COMMONWEALTH OF KENTUCKY
BEFORE THE PUBLIC SERVICE COMMISSION

ELECTRONIC JOINT APPLICATION OF)	
KENTUCKY UTILITIES COMPANY AND)	CASE NO.
LOUISVILLE GAS AND ELECTRIC COMPANY)	2022-00402
FOR CERTIFICATES OF PUBLIC)	
CONVENIENCE AND NECESSITY AND SITE)	
COMPATIBILITY CERTIFICATES AND)	
APPROVAL OF A DEMAND SIDE)	
MANAGEMENT PLAN)

TESTIMONY OF ANNA SOMMER

**ON BEHALF OF JOINT INTERVENORS METROPOLITAN HOUSING
COALITION, KENTUCKIANS FOR THE COMMONWEALTH, KENTUCKY
SOLAR ENERGY SOCIETY AND MOUNTAIN ASSOCIATION**

3 **Figure 1. The Companies' Modeling Process**

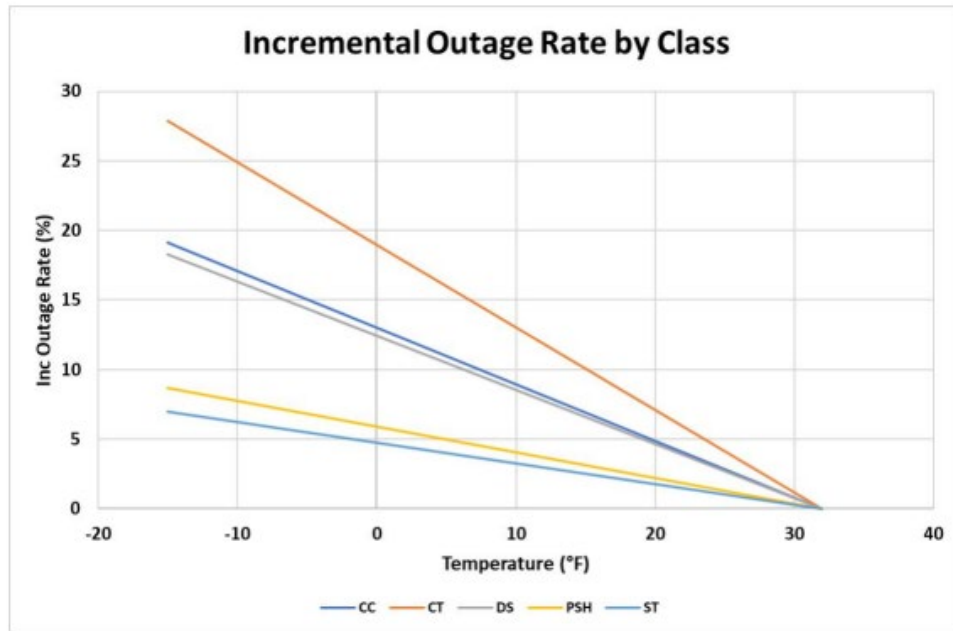
4 Three key changes to this process from the 2021 IRP are worth noting. First, the
 5 Companies are modeling each year of the planning period in PLEXOS, rather than just
 6 the last year. Second, the Companies developed a full set of production costs for more
 7 than one plan. And third, the Companies evaluated the reliability impact of their preferred
 8 plan in SERVM rather than merely relying on the modeled reserve margin to inform the
 9 question of whether the portfolio is reliable or not. These three steps are all
 10 recommendations that EFG made in our report on the Companies' 2021 IRP. I applaud
 11 the Companies for making these important improvements.

12 Notwithstanding those improvements, the Companies' modeling approach still
 13 effectively reduces the plans it evaluates to a single portfolio of resources that I will call
 14 the "Companies' Preferred Plan" throughout my testimony. The Companies' Preferred

11
12 **Figure 3. NGCC Cost per kW Comparison between 2013 and 2022 HDR Feasibility Study¹⁹**

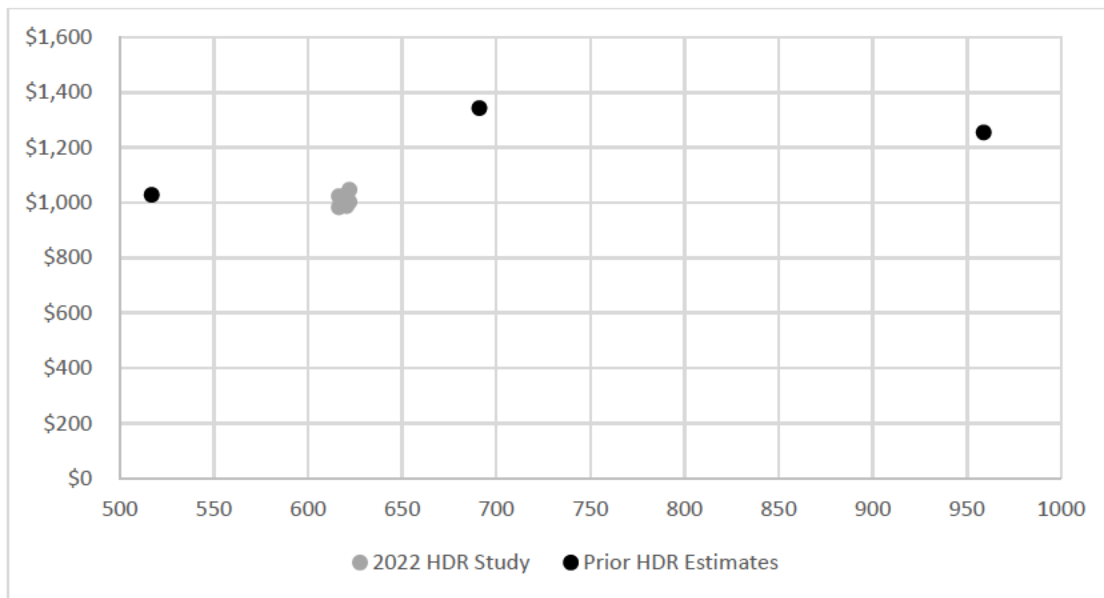
1 scope was managed on a limited budget. It is not clear what PO# 1070477 refers to, but
2 HDR was also the Companies' Owner's Engineer ("OE") that performed the 2013
3 feasibility study for the NGCC that would have been located at the E.W. Brown site, so
4 that study may have helped inform this work.
5 Both the 2013 and 2022 feasibility studies include multiple NGCC configurations. The
6 Companies plan to install J or H class turbines¹⁸ and the configurations including those
7 turbines are smaller in size in the 2013 study than in the 2022 study. Nevertheless,
8 whether in comparison to the small J/H configurations or the larger F class
9 configurations, the costs in the 2013 study are higher than the costs of the NGCC
10 configurations in the 2022 study as shown in Figure 3.

1 It was not possible to adjust these costs so that they capture the same construction
2 financing assumptions, pipeline and interconnection costs, turbine classes, or are divided
3 by the same capacity measure, e.g. summer rating, or are adjusted for differences in
4 regional labor costs, etc. so the figure should be taken as a rough comparison.

Figure 5. Index Measures of Selected NGCC Inputs Compared to CPI

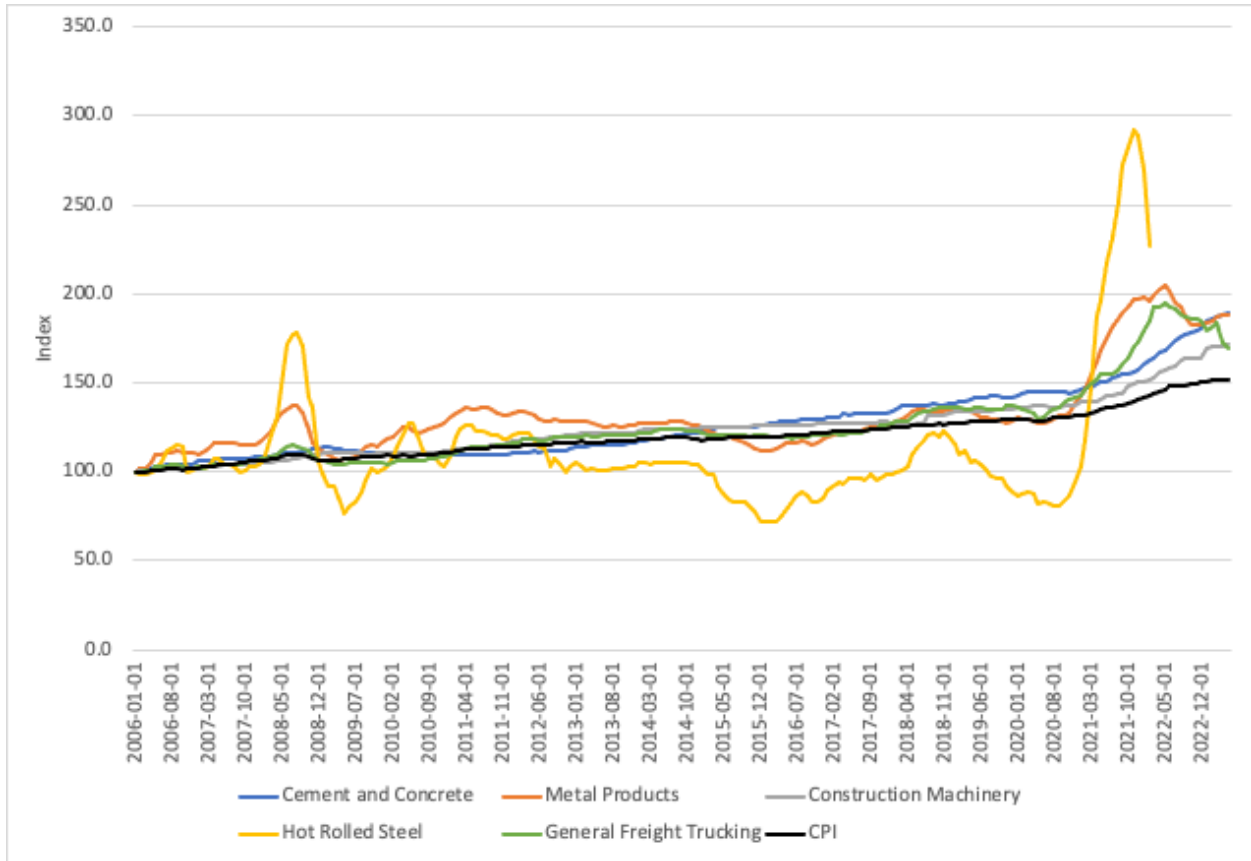
4 A. No, while there are some cost improvements to be expected from the advent of larger
5 simple cycle turbines, inflationary impacts have been felt broadly through our economy
6 and some of the key inputs into the NGCCs have experienced increases in excess of
7 inflation as shown in Figure 5.

Each of these indices for Cement and Concrete, Metal Products, Construction Machinery, Hot Rolled Steel, and General Freight Trucking have, for the last eight quarters or more, increased at rates that exceed the Consumer Price Index (“CPI”), a measure of inflation.

6
7 **Figure 11. Annual CO₂ Emissions by Portfolio**

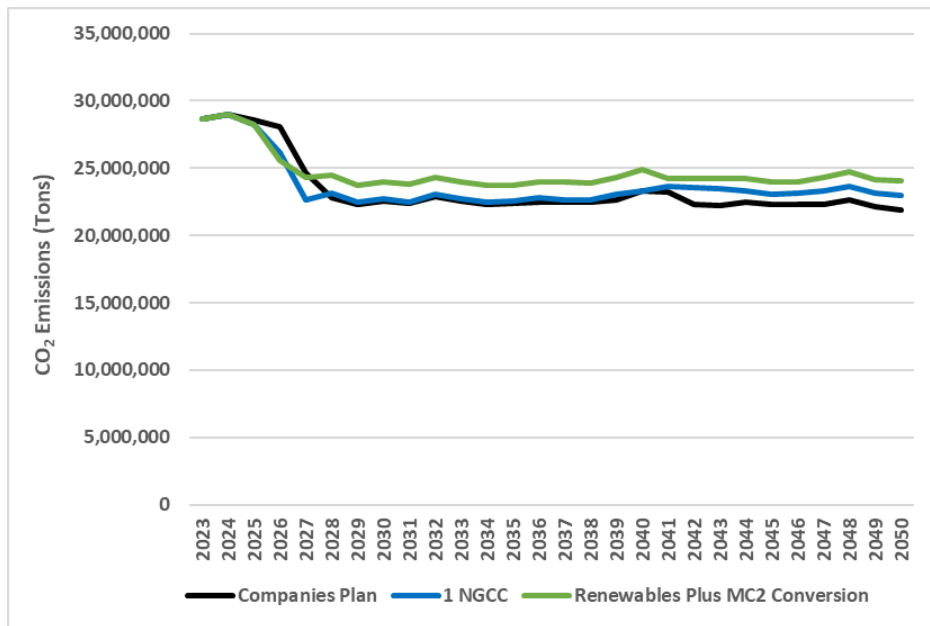
5 A. The CO₂ emissions for each portfolio are given in Figure 11.

3 **Figure 12. Comparison of Historical vs. Modeled Coal Generation**

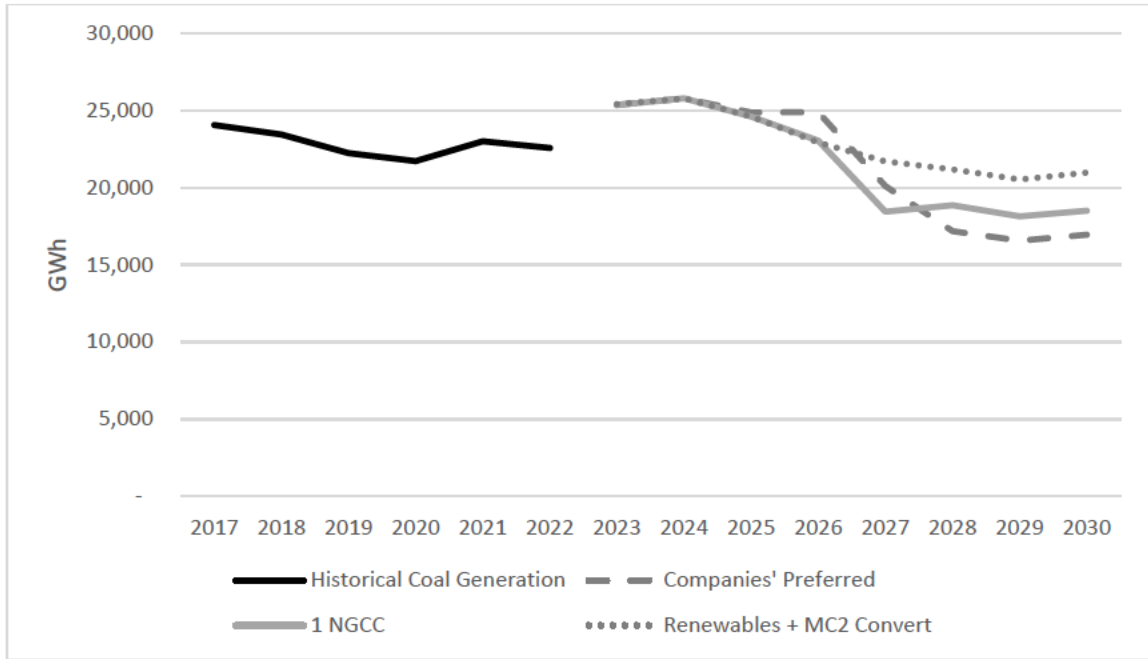
11 A. I do not think the Companies’ modeling gives a robust prediction of their CO₂ emissions
12 even in the near term. First, PLEXOS over-dispatches the Companies’ existing coal units
13 even in the first year of the planning period before any resource changes have happened
14 as shown in Figure 12. Starting in 2023, the first year of the simulation, the Companies’
15 PLEXOS model dispatched the coal units enough to produce about 2,800 GWh more
16 energy than they actually generated in 2022 – an increase of about 12% and noticeably

1 higher than any of the past seven years.
